LAA/AWA/19/19 (2)  
18<sup>th</sup> October 2019

Superseded by LAA/AWA/19/24

## Rotax 915i A & Rotax 912i (Series) Aircraft Engines Replacement of Fuel Pump Assembly

Pump Assembly Serial Numbers Affected.

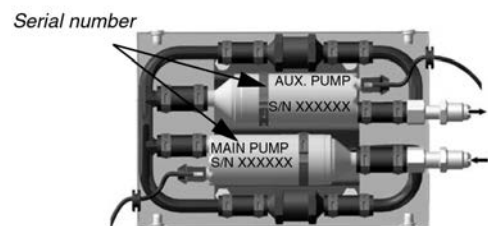
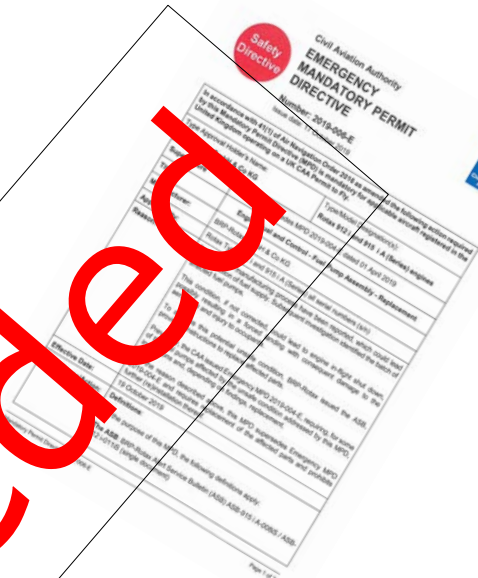
BRP Rotax have re-issued an Alert Service Bulletin (ASB) affecting aircraft fitted with the Rotax 915iA and Rotax 912i (Series) engine. The issue affects Rotax fuel pump assemblies with serial numbers which fall between a range specified in the ASB and below.

Fuel pump assy.	Description	Serial number
Part no. 889697	Fuel pump assy. UNF packaged (889696 + 3x 850620 + packaging)	from S/N 180500 up to S/N 192699 inclusive
Part no. 889699	Fuel pump assy. METRIC packaged (889698 + 3x 850620 + packaging)	from S/N 180500 up to S/N 192699 inclusive

The LAA has sent copies of the ASB and the MPD directly to all LAA 912i engine owning members with a letter authorising them to be able to sign out the aircraft themselves subject to ensuring that the pump assembly doesn't fall within the affected range.
